Item ID: D206-667-103TRN Accept *N900040100* Setup Start *NS1*
 Revision ID: Stop *NS2*
 Item Name: Crosstube Turning Detail
 Start Date: 10/20/2014 Start Qty: 1.00 *1* Cust Item ID:
 Required Date: 10/20/2014 Req'd Qty: 1.00 *1* Customer:
 Reference:

DART AEROSPACE LTD	Work Order:	125681
Description: Crosstube Assembly (206L High Fwd)	Part Number:	D206-667-143
Inspection Dwg: D206-667-143 Rev: C		Page 1 of 2

DRAWING NO. D206-667-143	TITLE CROSSTUBE ASS'Y (206L HIGH FWD)	REV. C	DART AEROSPACE LTD ENGINEERING ORDER		D.E.O. NO. D206-667-143-C-1	SHEET NO. SHEET 1 OF 1	SCALE NTS
DRAWN <i>P</i>	CHECKED <i>ASS</i>	MFG. APPR. <i>WJ</i>	APPROVED <i>WJ</i>		DE APPR. <i>WJ</i>		
DATE 11.07.15	DATE 11.07.20	DATE 11.07.21	DATE 11/07/21		DATE 11.07.21

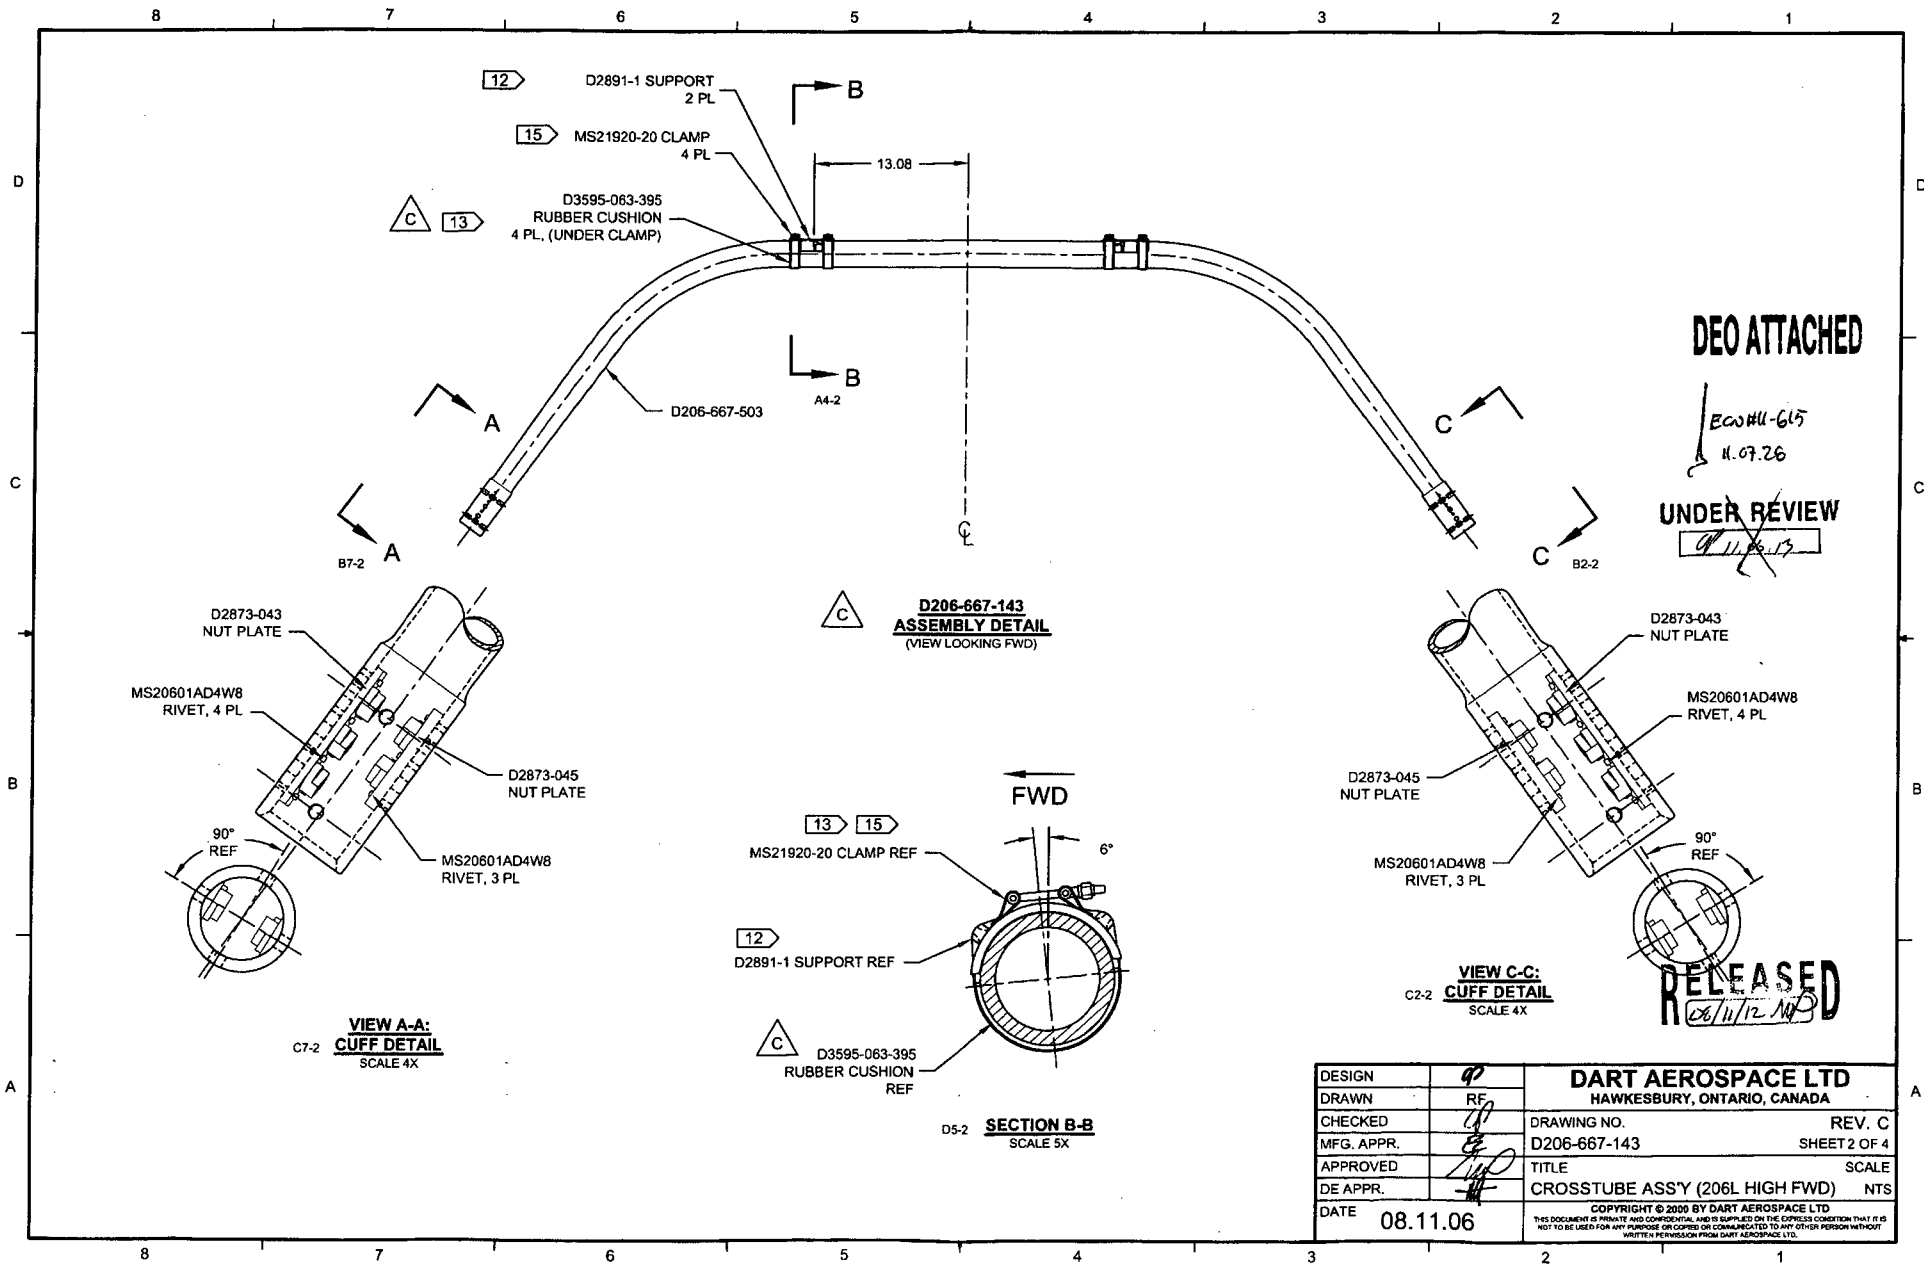
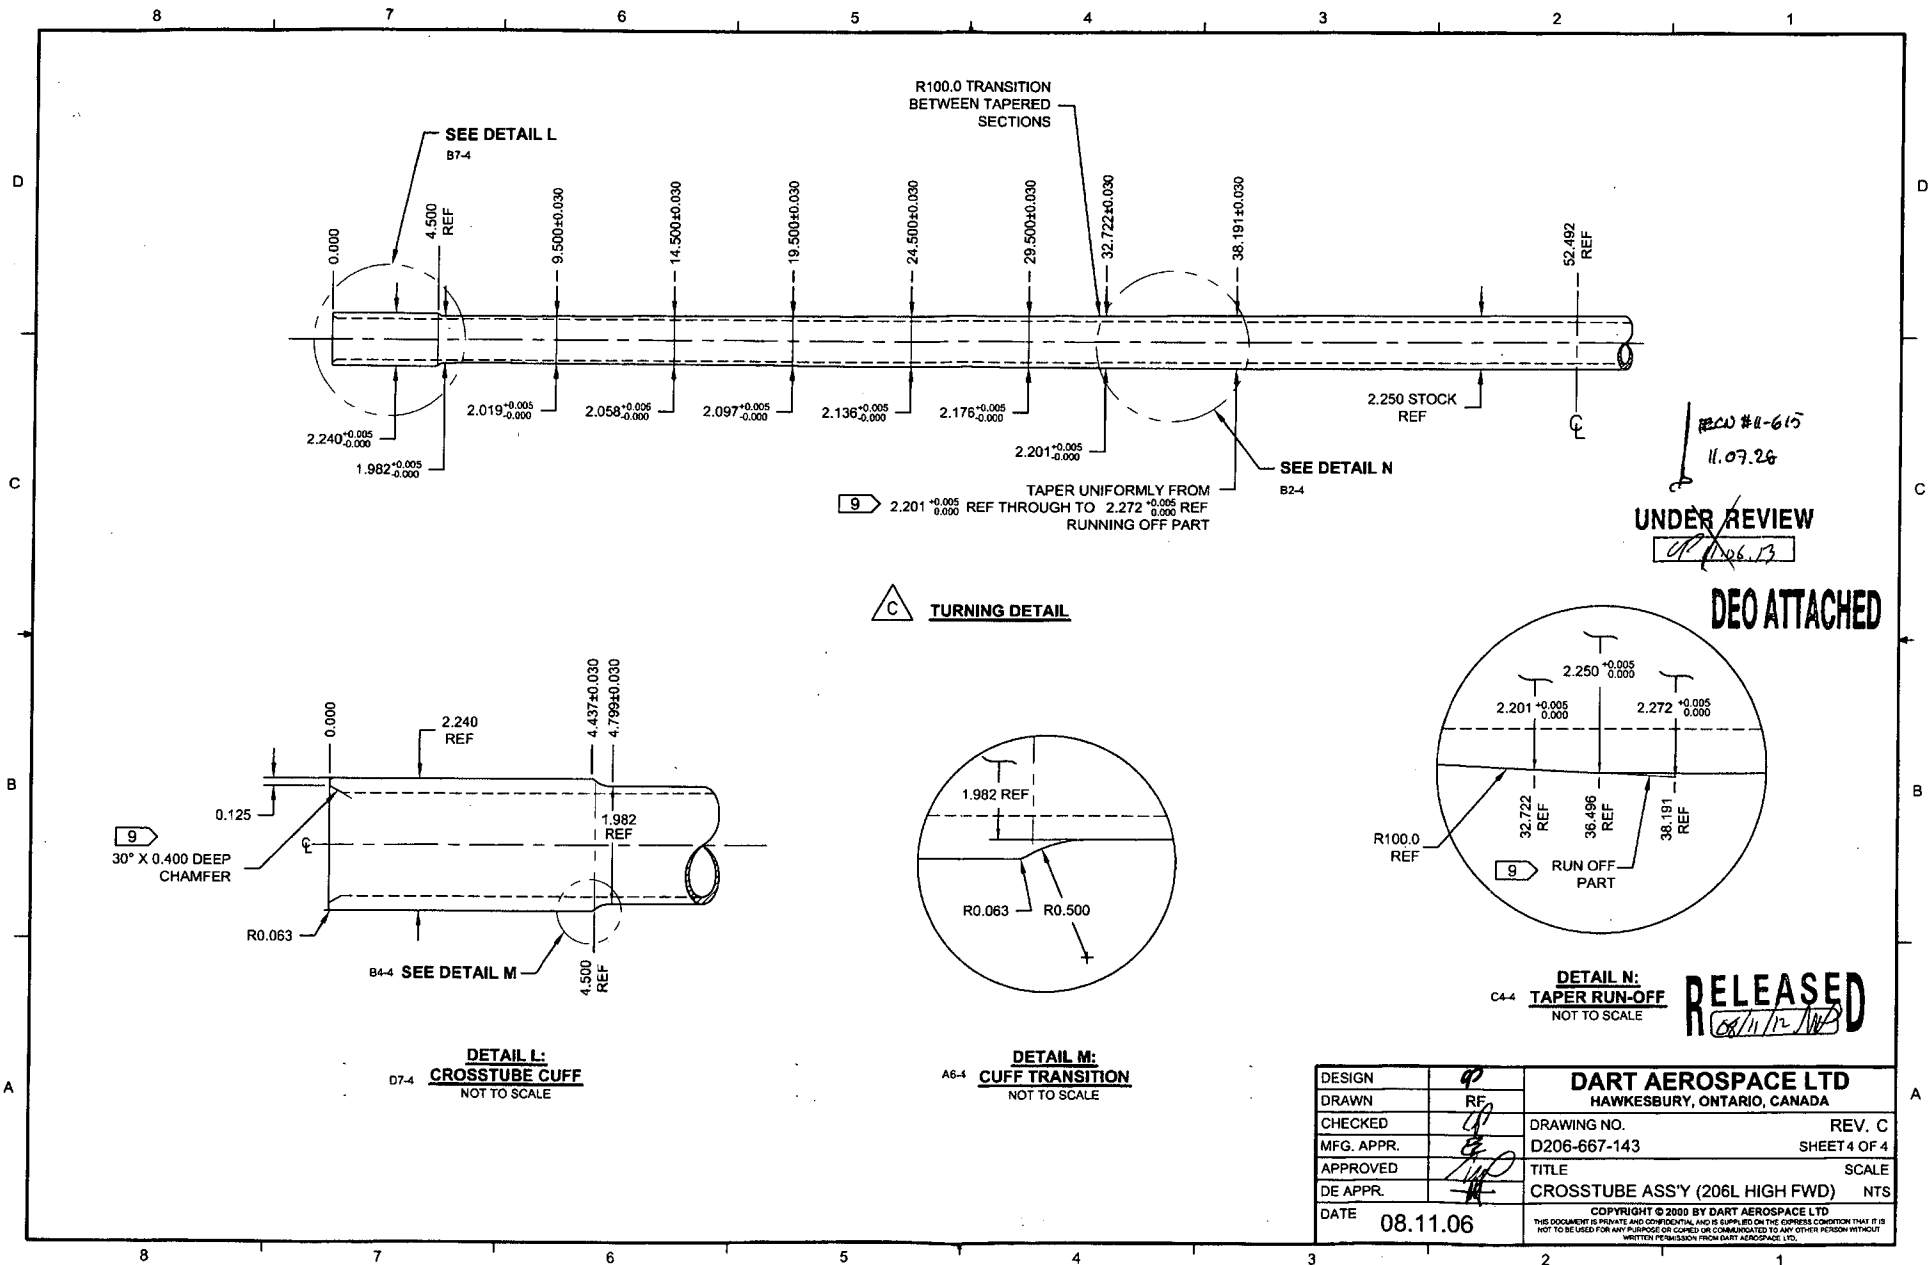
PURPOSE:

REPLACE MAGNOBOND WITH PROSEAL.

NOTE 12 & 15, SHEET 1 IS AMENDED AS FOLLOWS:

Item	Qty -143	Part Number	Description
9	A/R	PROSEAL 890 B-2	SEALANT, AMS-S-8802 CLASS B-2

- 12) TO INSTALL D2891-1 SUPPORT: ABRASE MATING SURFACE OF SUPPORT AND CROSSTUBE WITH 180-GRIT SANDPAPER AND REMOVE RESIDUE WITH MEK (OR EQUIVALENT). APPLY A 0.04" TO 0.07" THICK LAYER OF PROSEAL 890 CLASS B-2 (OR AMS-S-8802 CLASS B-2) SEALANT TO MATING SURFACE OF SUPPORT.
- 15) TORQUE CLAMPS 80 TO 100 IN-LB. ENSURE AT LEAST 1.5 THREADS SHOWING IN SAFETY AND THAT NUT HAS NOT BOTTOMED-OUT AFTER TORQUING. **PRIOR TO PACKAGING, RE-CHECK TORQUE ON CLAMPS AFTER PROSEAL 890 SEALANT HAS CURED FOR 72 HOURS.**

DETAIL P
BONDING STRAP INSTALLATION 2 PL

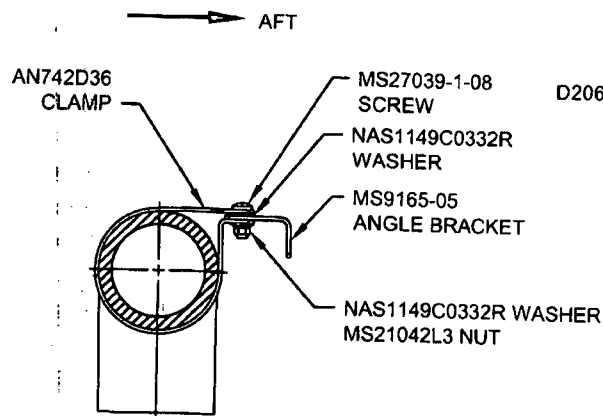
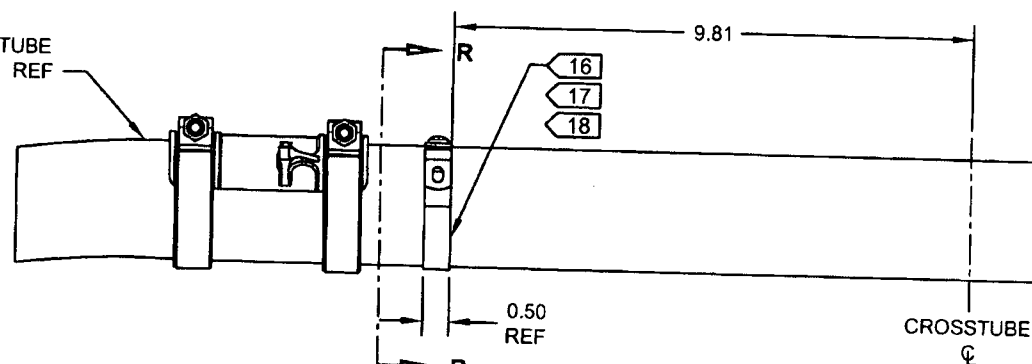
PURPOSE:

ADD ELECTRICAL GROUNDING STRAP

ITEM	QTY -143	PART NUMBER	DESCRIPTION
1	X	D206-667-143	CROSSTUBE ASSEMBLY (206L HIGH FWD)
10	2	AN742D36	CLAMP
11	2	MS9165-05	ANGLE BRACKET
12	2	MS21042L3	NUT (OR MS21042-3)
13	2	MS27039-1-08	SCREW
14	4	NAS1149C0332R	WASHER (OR AN960C10L)

- 16) MASK AREA UNDER CLAMP PRIOR TO PAINTING
- 17) SEAL EDGES WHERE AN742D36 CLAMP MEETS WITH THE CROSSTUBE USING SIKAFLEX-241/-291 OR MIL-S-8802 CLASS B2 OR PROSEAL 890 SEALANT
- 18) PERFORM RESISTANCE CHECK TO ENSURE MAX RESISTANCE IS 10 MILLIOHMS
